Cabinet Mounting Screws Missed Wall Backers

Bulletin Type:	Standard Repair Procedure SRP		Publication Date:	February 2020
Bulletin #:	20-005		Makes:	Jayco Entegra
Job Code(s):	de(s): **		Models:	Redhawk SE Redhawk
Flat Rate(s):	**			Esteem Odyssey
** If affected unit has warranty remaining, submit claim following the normal process.			Model Year:	2020
Incident:		Medicine cabinet mounting screws missed horizontal wall backers.		
Affected Units:		Redhawk SE: L1GA, L1GJ Redhawk : L1XB, L1XJ Esteem: L3BD Odyssey: L3EB, L3ED, L3EJ, L3EK		
Parts Kit:		4 – Screw, RW QUAD 8 X 1.50 .67 DT 17 SB (0248555)		
Misc. Tools & Supplies:		Screw gun with #2 square drive bit		
Parts Return Information:		N/A

FIG 2:

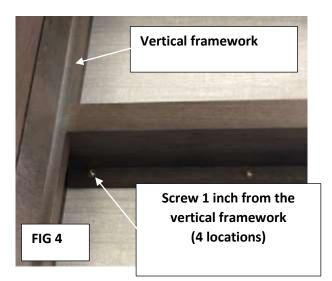
- There is one screw installed in the center of both shelf cleats (circled).
- Wall backers are 3 inches higher, and these screws miss those support backers.
